Review report

The “Golden Points” and nonequilibrium correction of high-accuracy frost point hygrometers

By Yann Poltera, Beiping Luo, Frank G. Wienhold, and Thomas Peter

50 hPa Abs Potential Vorticity [PVU], Heights [dam]

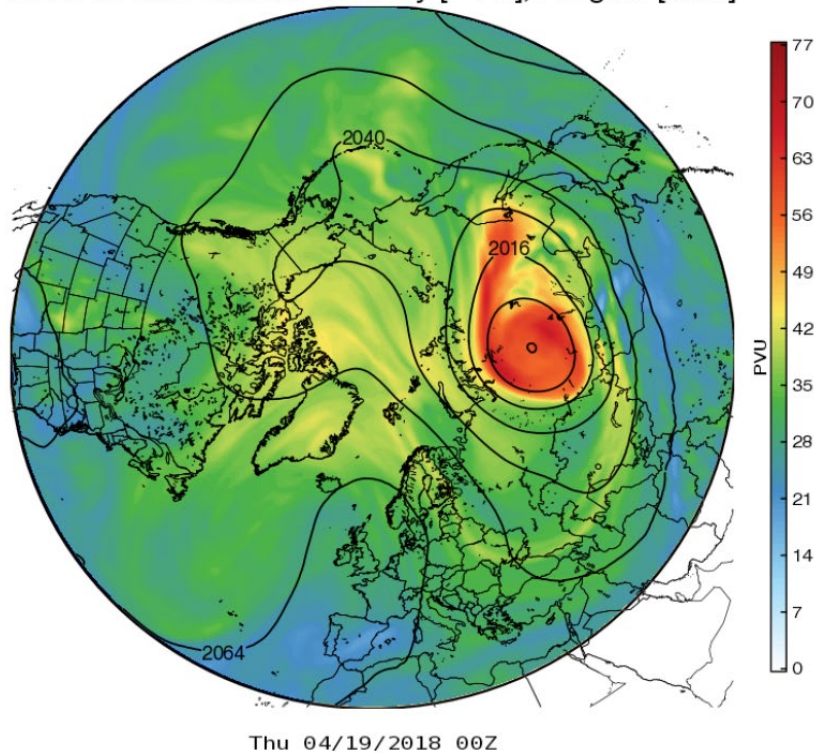
- Section 5.5.1, in particular, the part “High humidity and low number density of aerosol particles point to the polar vortex as a possible region of origin.”: Just out of curiosity, I looked at a reanalysis data set MERRA-2 (<https://gmao.gsfc.nasa.gov/reanalysis/MERRA-2/docs/>) whether this could be a case. NASA/GMAO has a website, <https://fluid.nccs.nasa.gov/reanalysis/>, where we can quickly see weather charts, for example, of potential vorticity at 50 hPa over the Arctic region:
https://fluid.nccs.nasa.gov/reanalysis/classic_merra2/?stream=MERRA2&field=epv&level=50&fcst=20180419®ion=nps&tau=00&track=none

The above figure shows that air mass with relatively high PV values (maybe in the form of differential advection) was actually coming to the western Europe region. The maximum PV stream (colored in yellow) over Europe is located somewhat to the east, but this may be related to difference in time (00 UTC for this figure), actual balloon trajectory, the choice of 50 hPa, etc. More investigation would be needed by downloading and analyzing full model-level reanalysis data (e.g., MERRA-2, ERA5, etc.) to investigate whether the hypothesis is true, although I am not suggesting to do so for this paper manuscript.
